## PROPOSED CHANGE

NBC05-DivB-09.13.04.03.-add-HSB-general\_SC-A\_ed.doc

Add new Appendix Note A-9.13.4.3. as follows:

#### **A-9.13.4.3. Providing the Rough-in for a Subfloor Depressurization System**

**Figure A-9.13.4.3.-A**  
**Configuration of a depressurization system – venting at roof level**

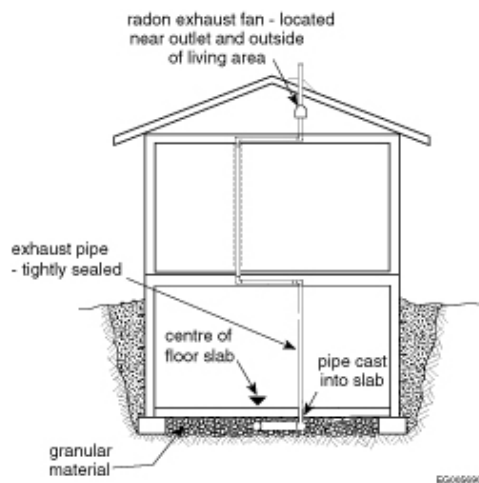
The extension of the pipe should be at least 100 mm in diameter and should be insulated to minimize condensation.

If the pipe discharges independently through the roof, it should

- be located no less than 3 m from any other opening, and
- extend no less than 200 mm above the roof's surface.

### Figure A-9.13.4.3.-B

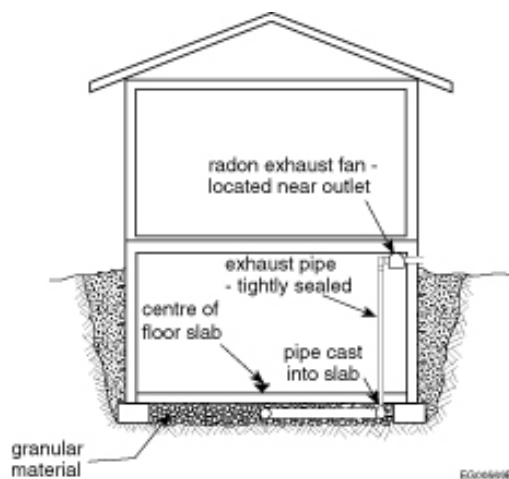
Alternatively, the pipe can discharge through an attic gable or an exterior wall. In the latter case, because the exhausted air may contain unacceptable concentrations of radon, re-infiltration of exhausted air into occupied space should be avoided by locating the discharge pipe

- [no less than 300 mm above grade,](#)
- [no closer than 3 m from any other opening, and](#)
- [no less than 2 m from the property line.](#)

[The exhaust opening should be protected against the entry of animals and the ingress of precipitation by the use of louvres, weather cowls or other suitable means.](#)
